UNITED STATES PATENT AND TRADEMARK OFFICE

10/552,097

Office Action Summary	Application No. 10/552,097	Applicant(s) CHOW ET AL.	
	Examiner JOSHUA J. MICHENER	Art Unit 3644

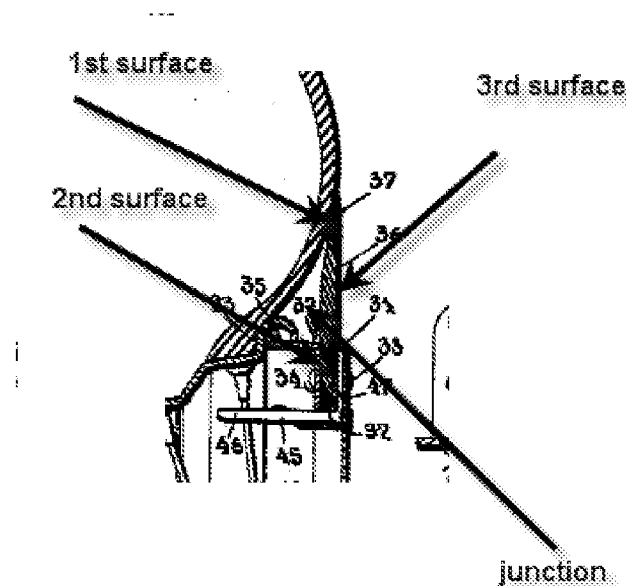
Roth discloses it is known to have a separate part on both sides of the wheel with a first surface in contact with the tire (see figure below), the second surface in contact with the rim (17,23,35,32,34) and third surface extending across the gap on an aircraft wheel (see figure below) wherein the separate part is flexible and made of rubber (col 2, line 21) thus deformable and capable to be moved manually.

Regarding claim 33, Large, as modified, discloses the apparatus as in claim 15 wherein the first surface follows the shape of the tire (see figure above).

Regarding claim 34, as best understood, Large, as modified, discloses the apparatus as in claim 15 wherein the first surface follows the shape of the wheel (see figure above).
